Attachment 7 – Apartment Design Guidance Compliance Table

Apartment Design Compliance Table				
	Objective	Design Criteria	Proposed	Council Comments
Apartment Building Types	Objective 1A	<p>Shop top apartments are mixed use residential buildings often located in established centres, along main streets or close to public transport hubs. They can be small infill or larger developments where the ground floor is occupied by retail or commercial uses. Shop top apartments typically range between two and six storeys and are best used when:</p> <ul style="list-style-type: none"> • increased residential uses are desired in established retail and commercial areas • the context is a traditional main street • zero setbacks to side boundary walls are possible or desired • active frontages such as retail tenancies are desired at street level • pedestrian activity on the street is desired • rear lane access is available. 	<p>Apartments located above commercial use (hotel) and located in developing Town Centre Precinct within Shell Cove.</p> <p>Active frontages provided at ground floor level (food and drinks premises/hotel lobby.</p>	<p>The proposal is located within precinct D of the Shell Cove

Figure 7.2 – Vehicle and Pedestrian Access Detail

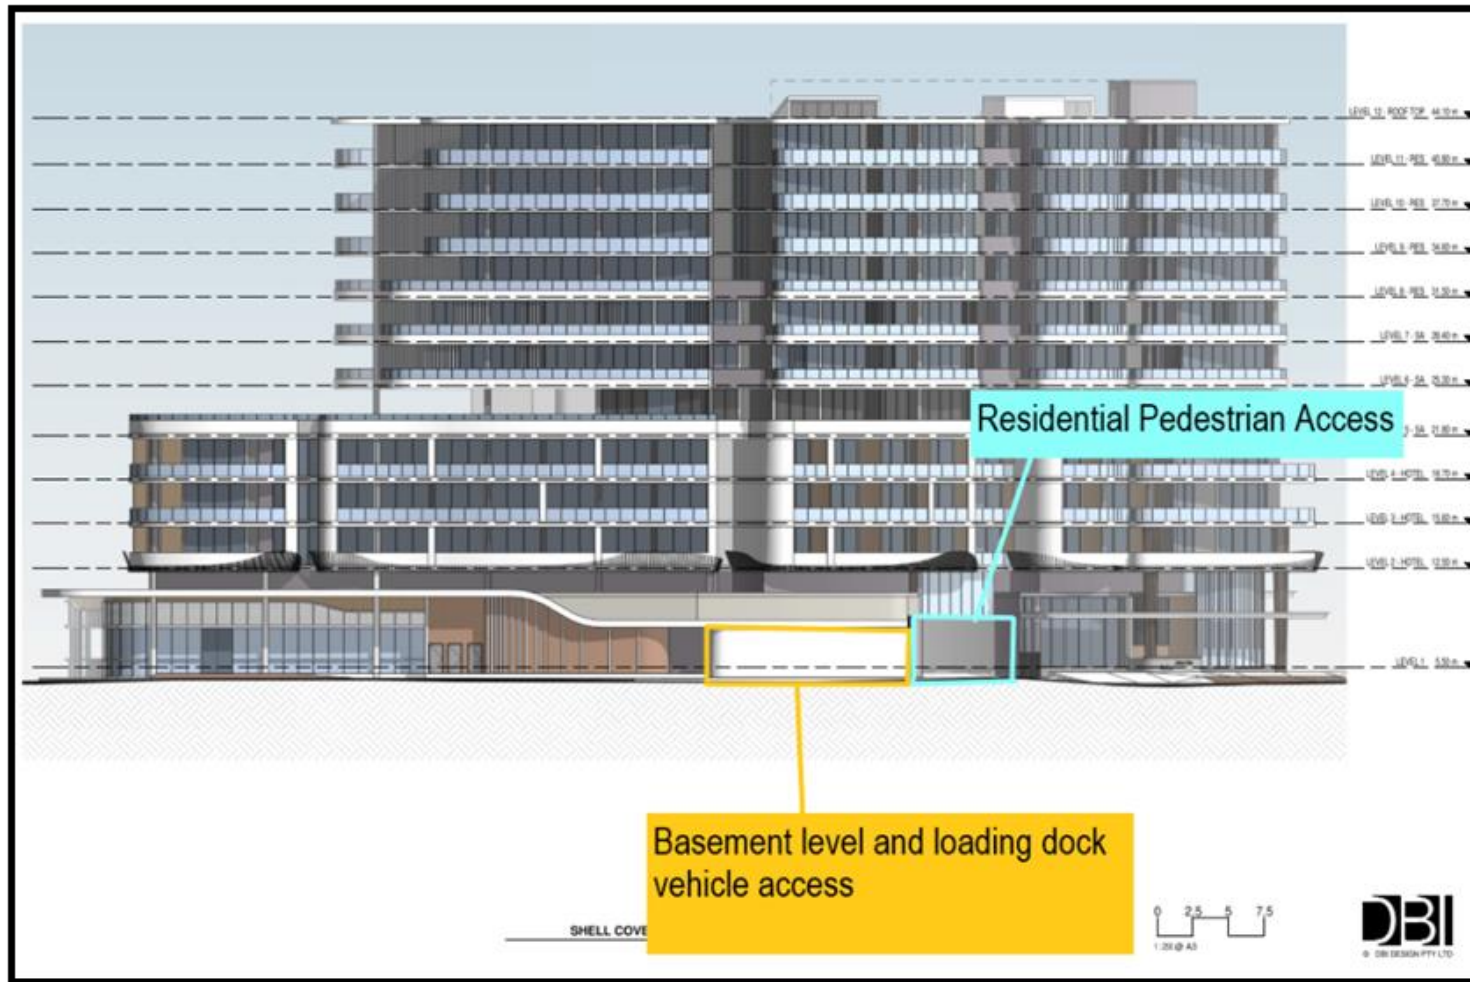
Objective 3G-2	Access, entries and pathways are accessible and easy to identify.	Each building access point is clearly visible from the public domain. Signage integrated with the building's architecture clearly mark these entries.	Suitably complies
Vehicle Access	Objective 3H-1	Vehicle access points are designed and located to achieve safety, minimise conflicts between pedestrians and vehicles and create high quality streetscape	<p>The vehicular access point was selected and coordinated with the consulting traffic engineer while complying with the Urban Design Guidelines in Precinct D.</p> <p>Residential car parks will be accessed via electronic security devices and intercom for visitors. Car parks will be well lit and lifts will have security control and close circuit television cameras.</p> <p>Loading dock screened from street view along boundary line, roller shutter located for access.</p> <p>Basement Entry point located along Aquatic Drive preferred by Hydraulic Consultants to suit peak flood levels</p>	<p>Vehicle access point to residential basement parking will be from Aquatic Drive to the north of the site. The ramped access will be shared by the loading dock and visitors to the hotel, restaurant, function centre and bars, and staff for these uses.</p> <p>The vehicle entrance will be suitably separate from the pedestrian access.</p> <p>Elevation including in figure 7.2 included at the end of this attachment shows detail of locations for residential pedestrian access and basement vehicle/loading dock access.</p>
